OAKS OF FOWL RIVER SUBDIVISION, **RESUBDIVISION OF**

APPLICATION NUMBER 1 DATE October 5, 2017

REQUEST Subdivision

DETAIL SITE PLAN

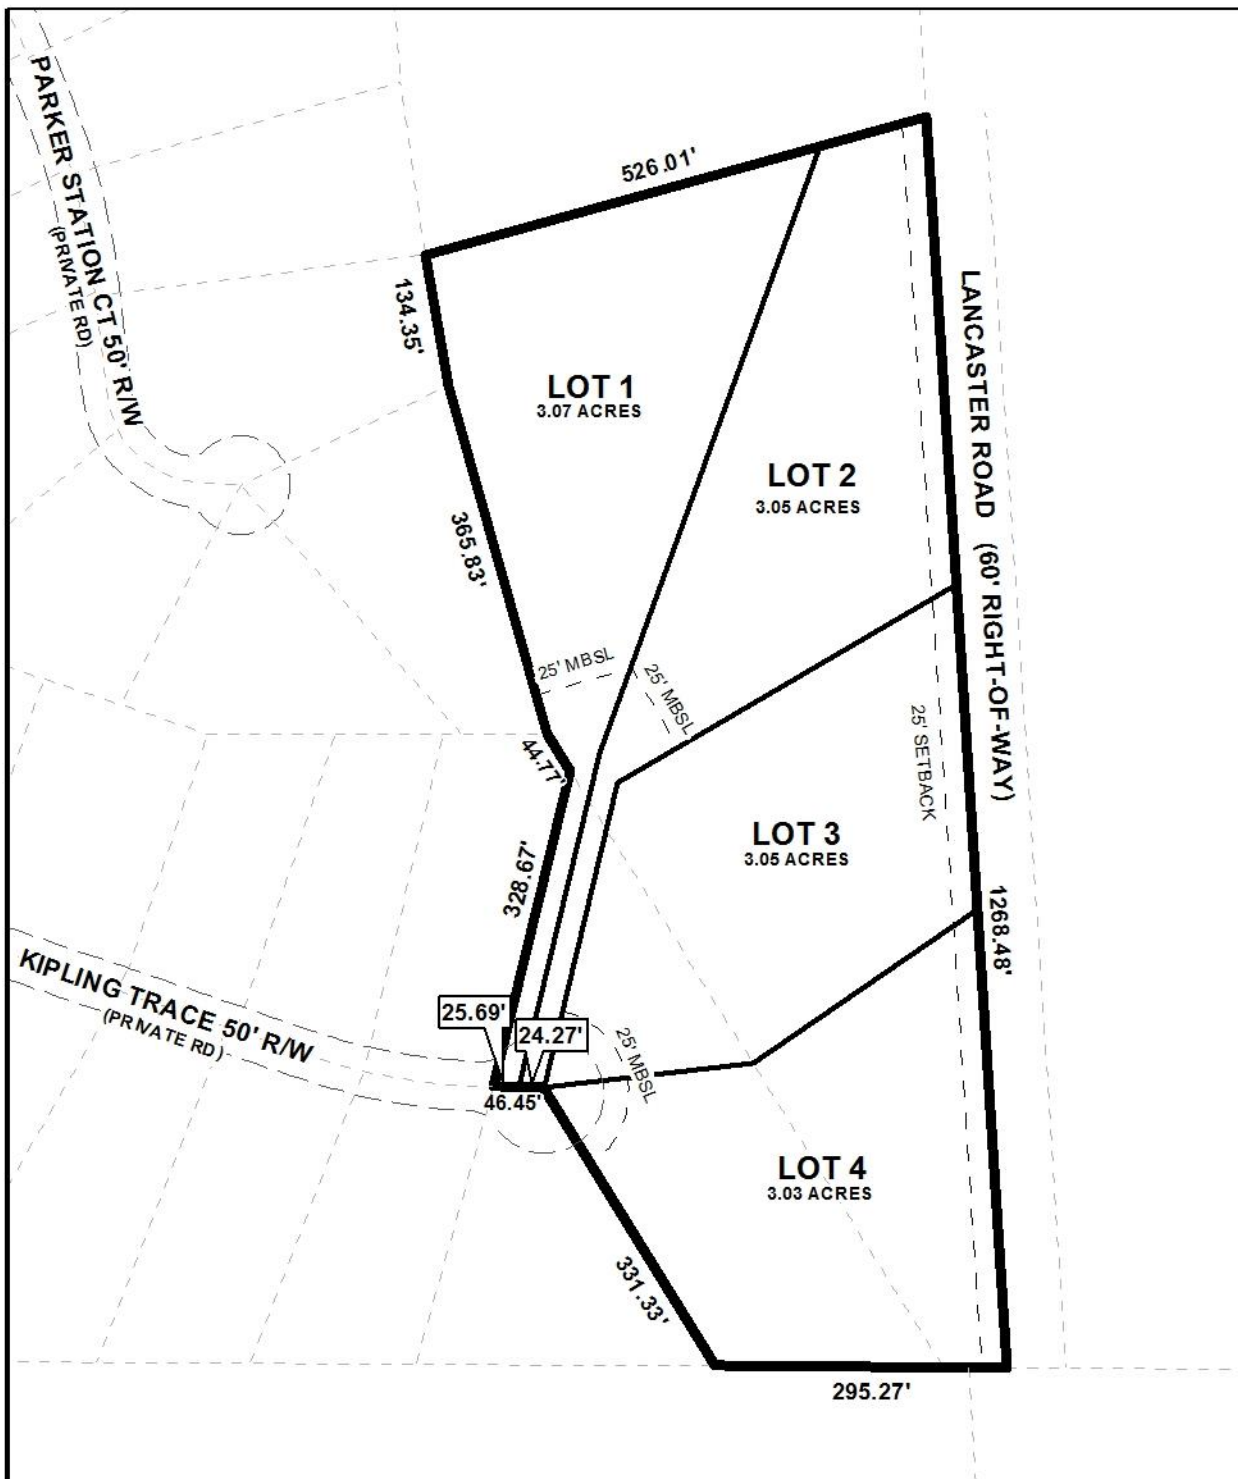
It should be noted that the proposed lot configurations create irregular shaped lots, specifically Lots 1 and 2. Lots 1 and 2 create a "panhandle" or "flag lot" shape, and is generally not allowed, but permitted only in those locations where varied and irregularly shaped lot designs are common and the informality of design is consistent with other lots in the vicinity; or where unusual circumstances such as an odd shaped lot exists; or separate disparate uses exist on a single lot; or where there are natural or pre-existing man-made barriers which may cause an undue hardship on the land owner; or in the case of a family division. Currently, there are no similarly-shaped lots within the immediate vicinity of the proposed subject lots.

The proposed lots front Kipling Trace and Lancaster Road. Kipling Trace is a private minor street without curb and gutter. As a minor street without curb and gutter, this street requires a 60' wide right-of-way width; however, Kipling Trace was established by a subdivision that was recorded in 2010, prior to the expansion of the Planning Jurisdiction and the applicability of the Planning Commission Subdivision Regulations. The right-of-way width is depicted as 50'. The proposed lots will also have frontage on an undeveloped portion of Lancaster Road. Lancaster Road is a minor street without curb and gutter that requires a right-of-way width of 60'. The

The 25-foot minimum building setback line is depicted on the preliminary plat for each proposed lot along both Kipling Trace and the undeveloped portion of Lancaster Road, and should be retained on the Final Plat, if approved,.

The lot size information is depicted in both square feet and in acres on the preliminary plat and should be retained on the Final Plat, if approved.

As a means of access management, a note should be placed on the Final Plat, if approved, stating that the each lot is limited to one curb cut to Kipling Trace, with any changes to the size, design and location of the curb-cut to be approved by Mobile County Engineering and conform to AASHTO standards. Access to Lancaster Road is denied.

- 1) There are no other flag lots in the vicinity, and thus, does not comply with Section V.D.1. of the Subdivision Regulations.

As stated at the last meeting, the proposed subdivision does not comply with Section V.D.1. of the Subdivision Regulations. There are no other flag lots within the immediate vicinity of the subject property, and thus the recommendation for denial still stands.

- 1) There are no other flag lots in the vicinity, and thus, does not comply with Section V.D.1. of the Subdivision Regulations.*
